Multi-Modal Circulation, Streetscape, and Storm- water

~~Multi-Modal Circulation, Streetscape,
and Stormwater~~
Draft: April 2018

This chapter describes policies, guidelines, and improvements for the Mill Site's multi-modal transportation network and parking management system. This chapter also includes policies and guidelines that address the design of streets, sidewalks, landscape treatments, stormwater management, street furniture, and street lighting in the Mill Site.

FIGURE 3-1

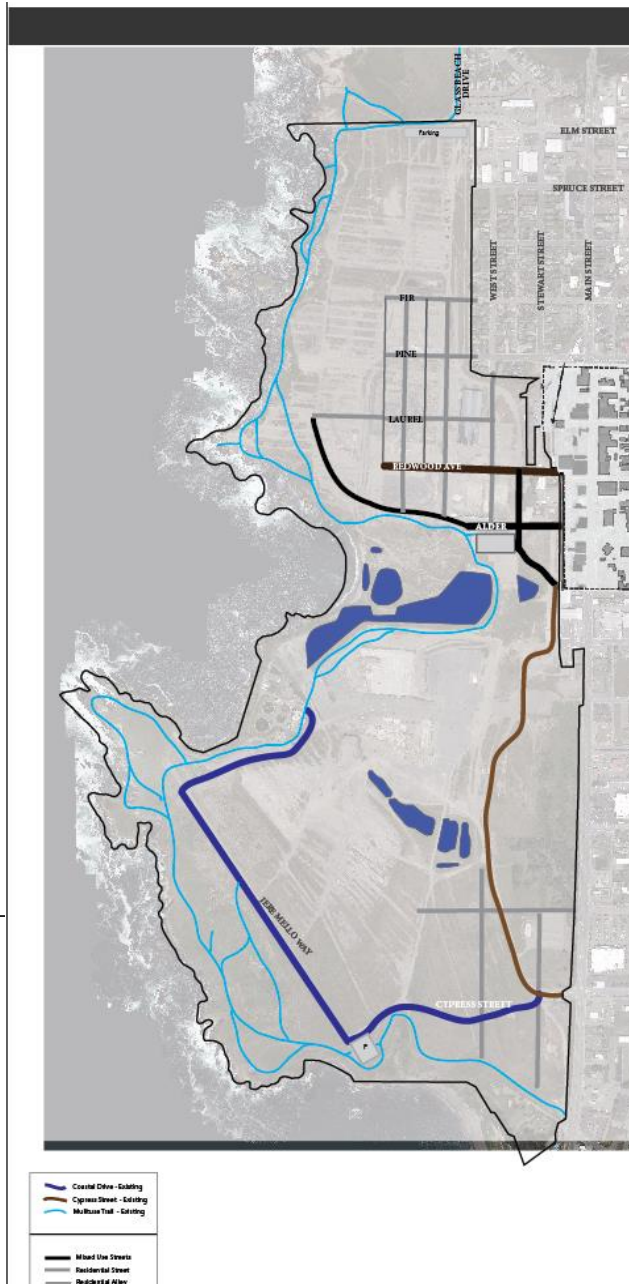
Comment [MJ1]: Applicant's may decide to realign roadways and cross streets within the plan area during the Mater Tentative Map stage for the site.

FIGURE 3-2 MIXED USE STREET/REDWOOD AVENUE ALTERNATIVE 1 (WITH STORMWATER PLANTERS)

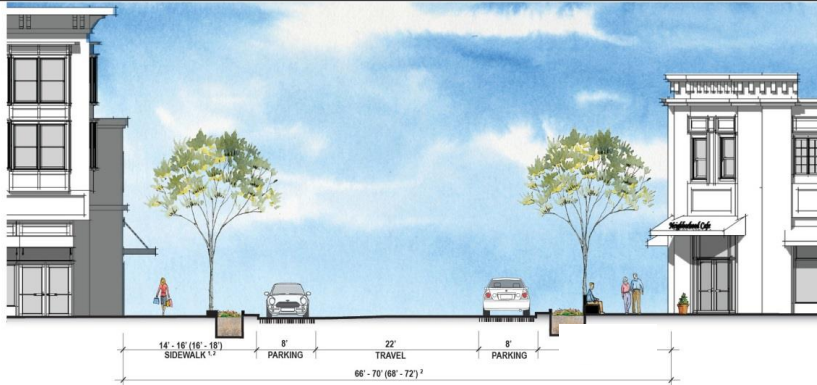
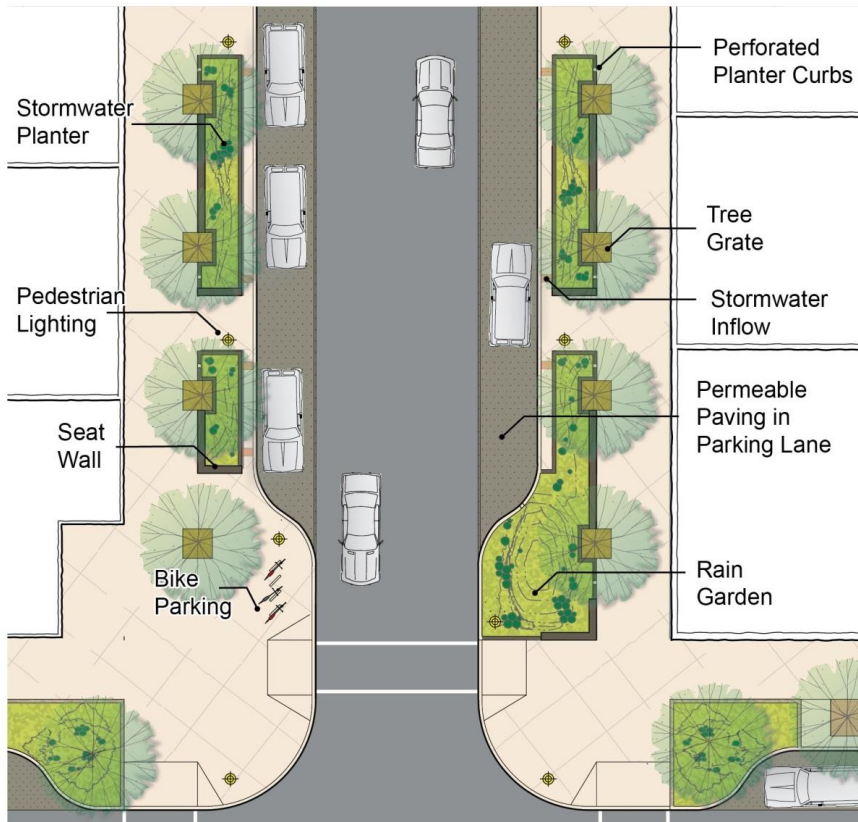
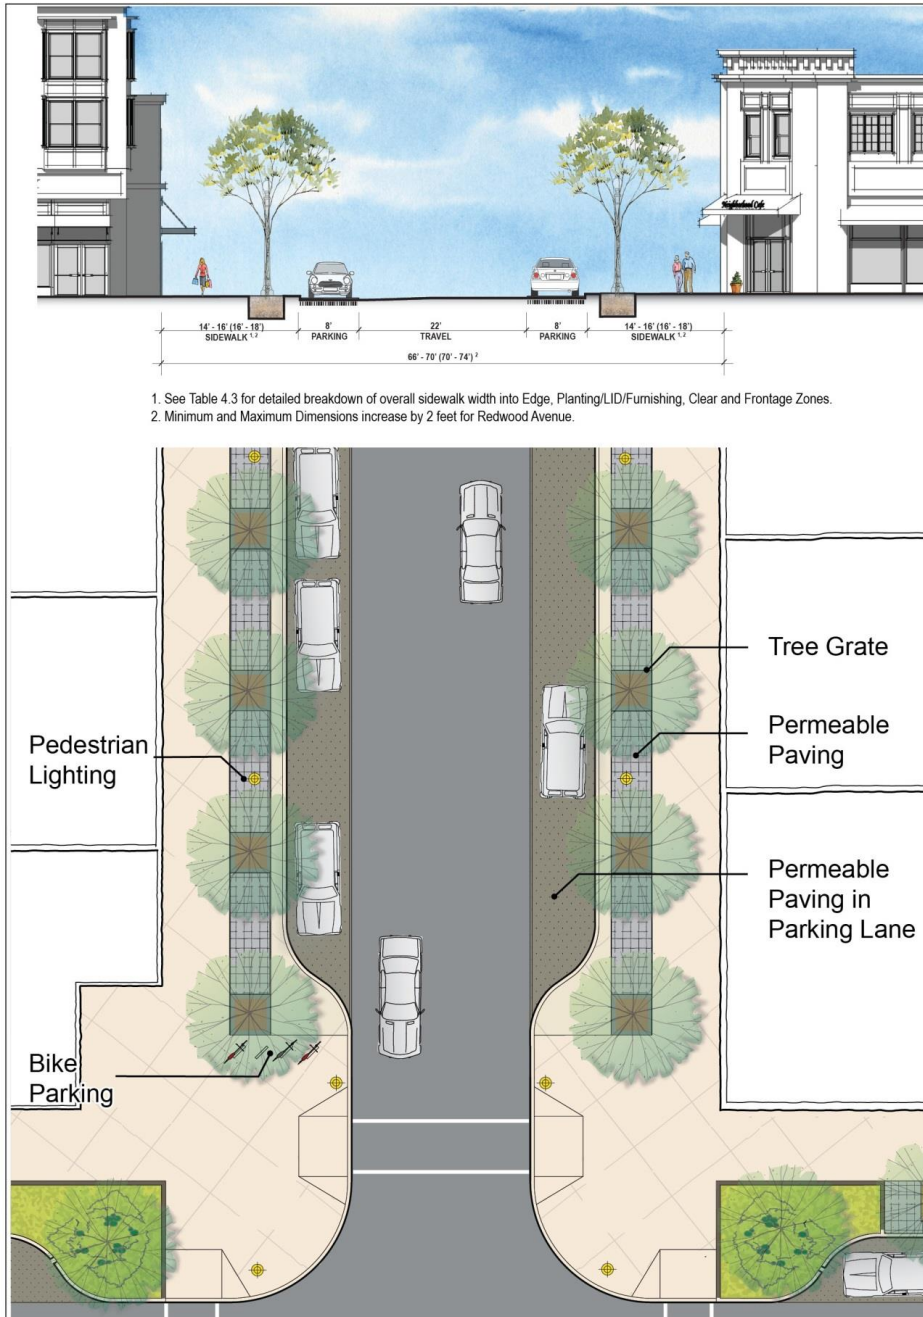
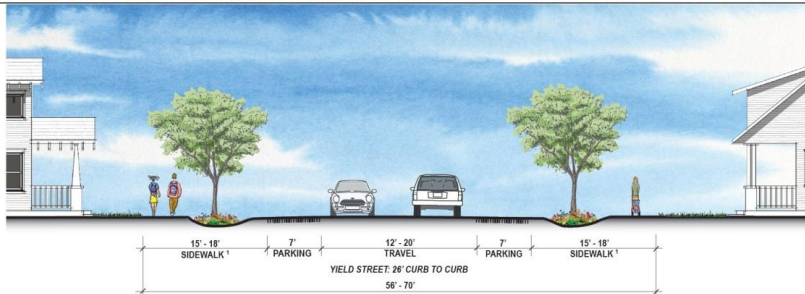
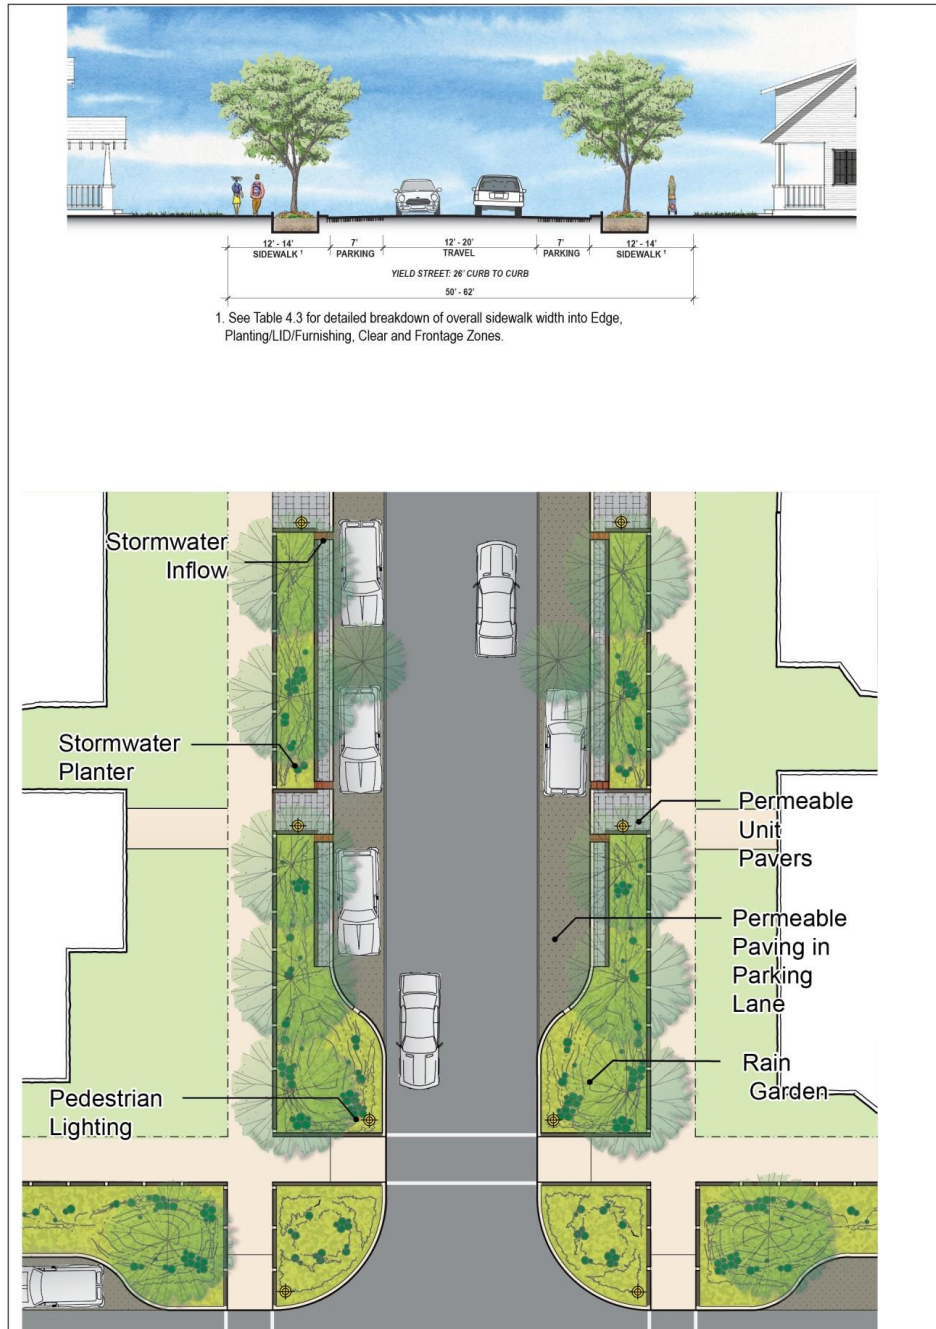
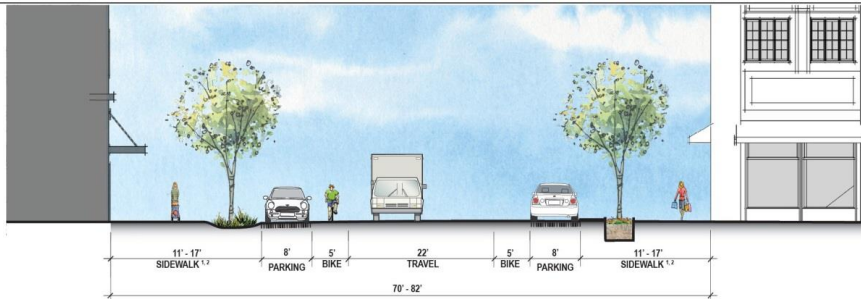
Comment [MJ6]: Recommend deleting these street typologies as they are very suburban and use up a lot of real estate. Current City streets are 50 to 60' ROW and these are 70+ ROW. Also no need to overdesign streets. It is better to have flexibility when a project is submitted.
